**Final Report - Corrections Required
Application No. DEPN-22-0222**

Description : A new 53 unit apartment complex
Address : 0 8th ST Colorado Springs CO 80905
Record Type : Development Plans
Document Filename : 3rd Submittal_Development Plan

VUE DE LA PARC
800 SOUTH 8TH ST
COLORADO SPRINGS, CO 80905

VUE DE LA PARC
DEVELOPMENT PLAN
PRELIMINARY GRADING

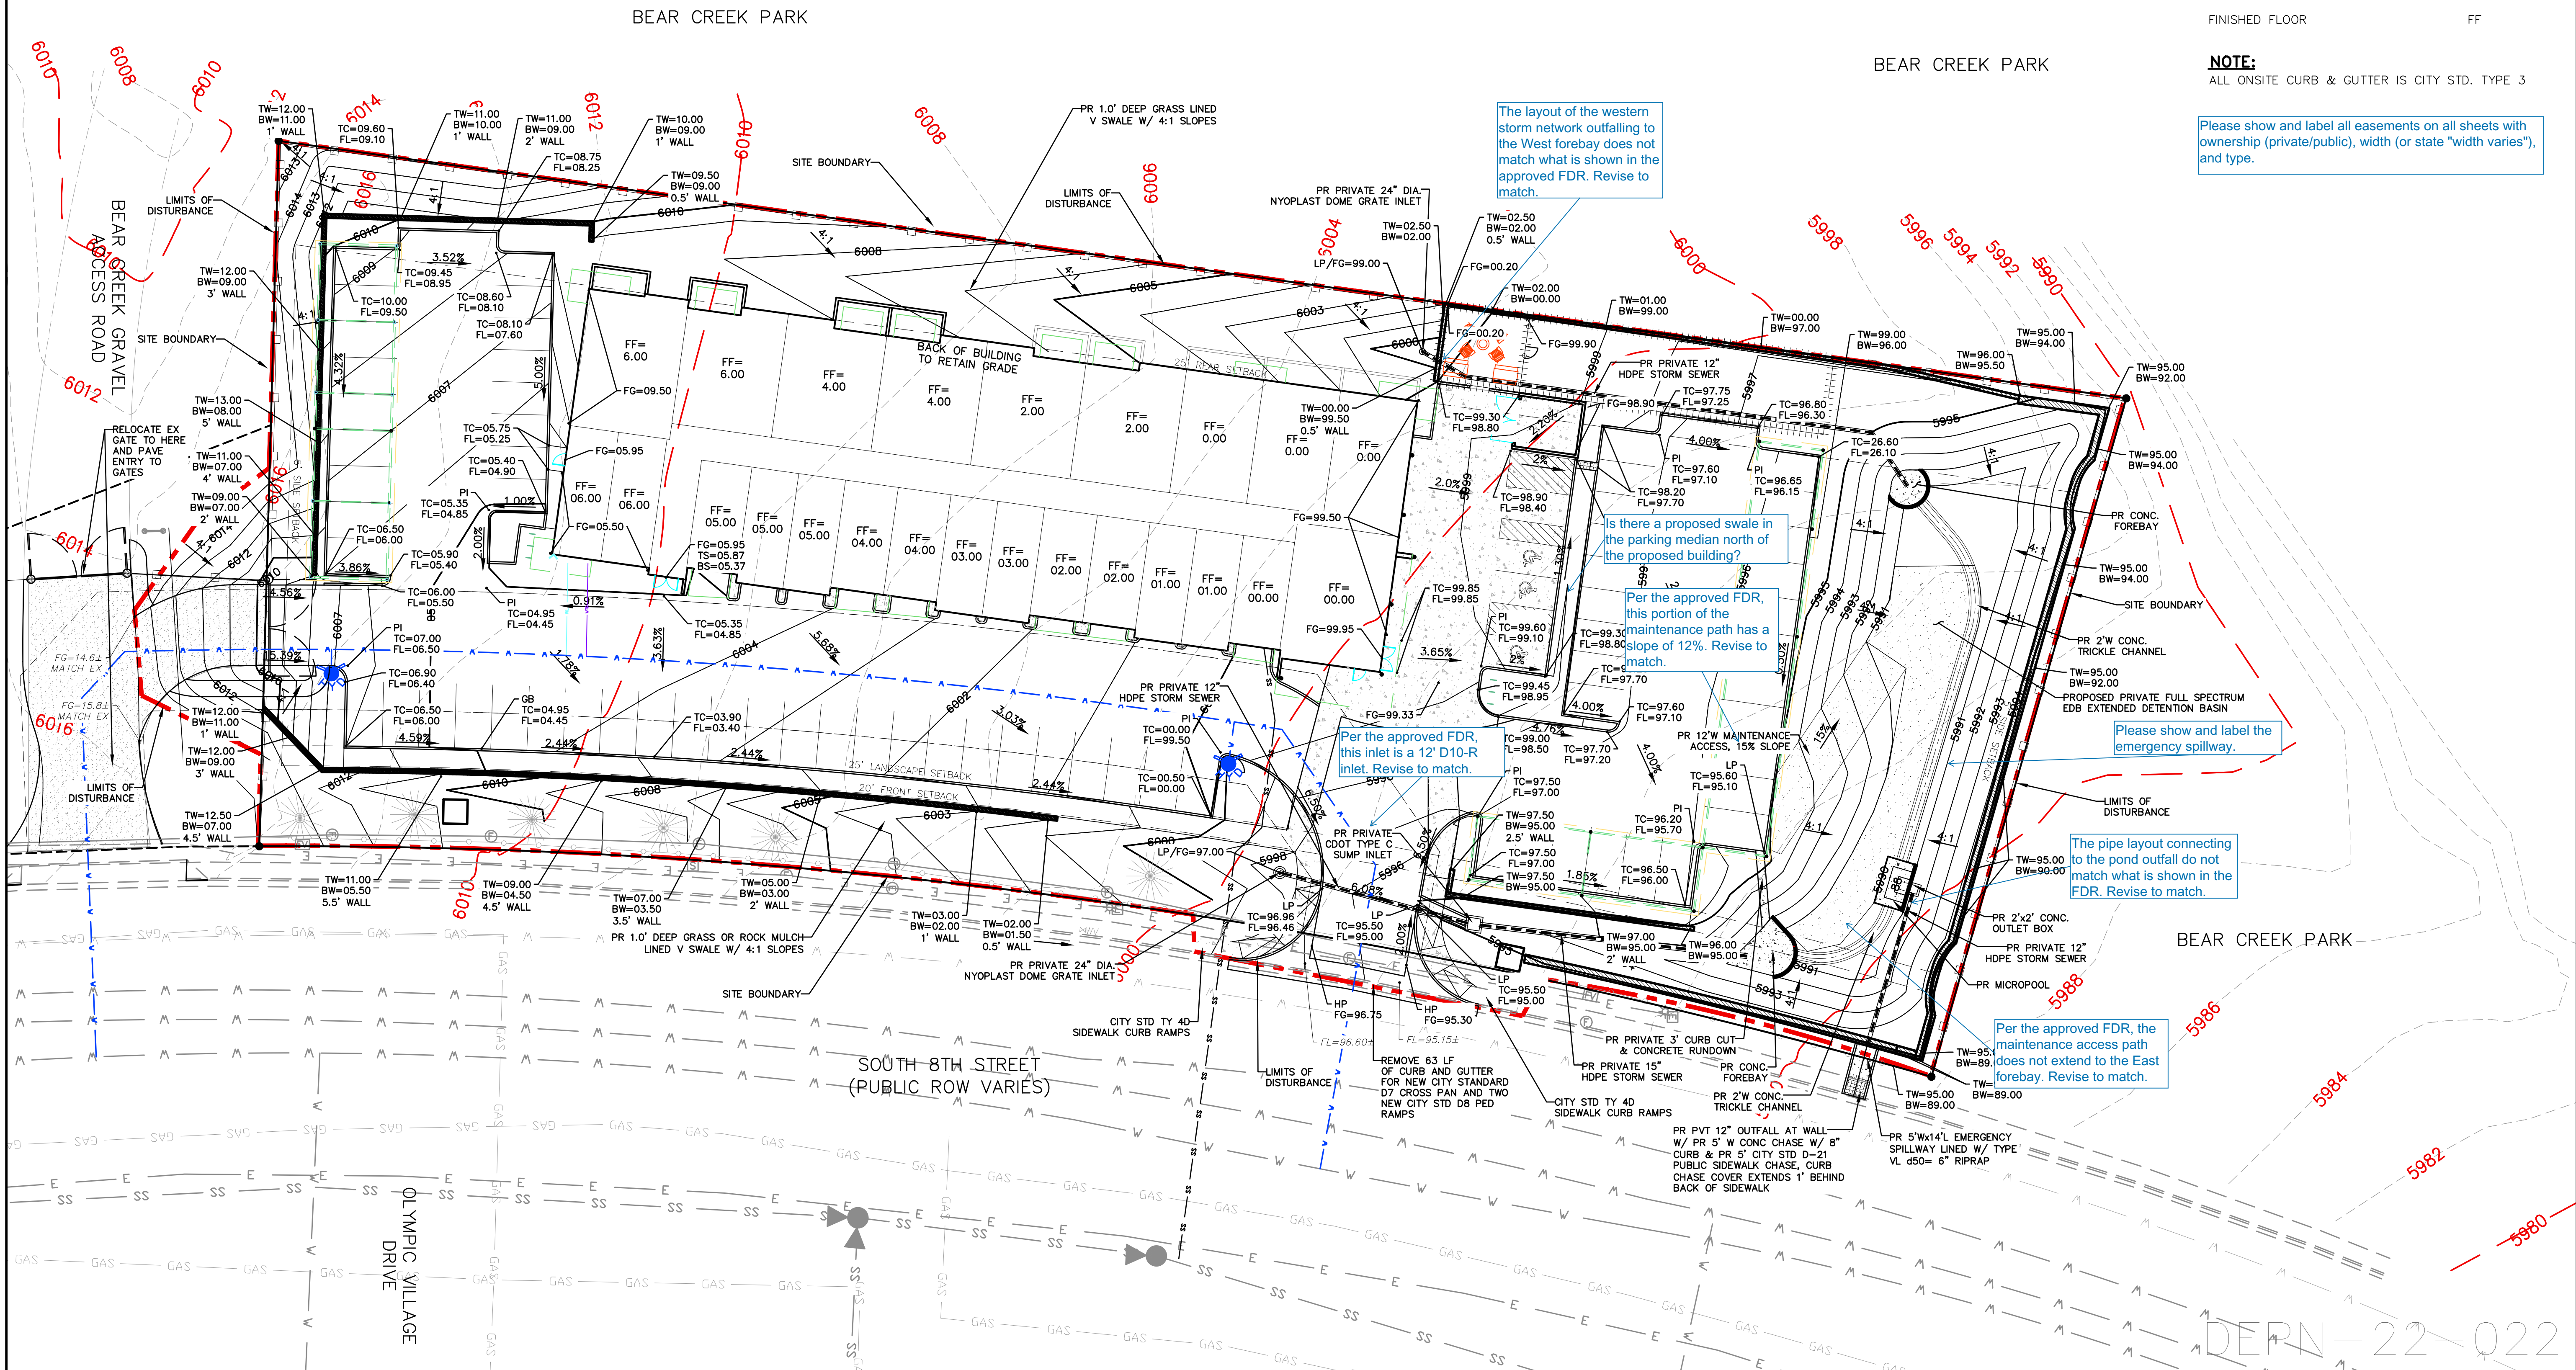
Comment ID	Page Reference	Author : Department	Review Comments
42	4	Hao Vo : City Engineering - SWENT	Per the approved FDR, this inlet is a 12' D10-R inlet. Revise to match.
43	4	Hao Vo : City Engineering - SWENT	Per the approved FDR, the maintenance access path does not extend to the East forebay. Revise to match.
44	4	Hao Vo : City Engineering - SWENT	Please show and label the emergency spillway.
45	4	Hao Vo : City Engineering - SWENT	The layout of the western storm network outfalling to the West forebay does not match what is shown in the approved FDR. Revise to match.
46	4	Hao Vo : City Engineering - SWENT	Per the approved FDR, this portion of the maintenance path has a slope of 12%. Revise to match.
47	4	Hao Vo : City Engineering - SWENT	The pipe layout connecting to the pond outfall do not match what is shown in the FDR. Revise to match.
48	4	Hao Vo : City Engineering - SWENT	Is there a proposed swale in the parking median north of the proposed building?

50	4	Hao Vo : City Engineering - SWENT	Please show and label all easements on all sheets with ownership (private/public), width (or state "width varies"), and type.
49	8	Hao Vo : City Engineering - SWENT	Please revise the text conflict on sheet 8.
55	1	Joel Dagnillo : City Engineering Dev Review	Add "potentially unstable slopes" to list of hazards in this statement.
56	1	Joel Dagnillo : City Engineering Dev Review	Please address all comments in CGS's review letter (dated December 21, 2022), revise the geological hazard report accordingly, then resubmit to the City.
41	5	Corey Masoumi : Col Springs Utilities	What is this? is it a T-wall? if it is a T-wall, it cannot be in our easement.
52	1	Matthew Alcuran : Planning	<p>El Paso County Park Comments:</p> <p>When construction commences, no construction activity may take place outside of the apartment property or the access easements we are providing. This means that staging, overburden, construction traffic, and workman egress cannot take place on EPC Park property. EPC parks understands that a retaining wall and other amenities will be located close to the property line. If Viceroy needs a temporary access agreement for construction activities, please advise EPC as soon as possible This agreement would allow (for instance) perhaps a 10-foot buffer around the property and the affected ground restored and reseeded. Erosion control measures would need to be utilized so construction material does not migrate into Bear Creek Park or the Equestrian Skills Course, which lies very close to the northwest corner of the property. EPC wants to ensure the property is protected and the project can move forward with no issues.</p>
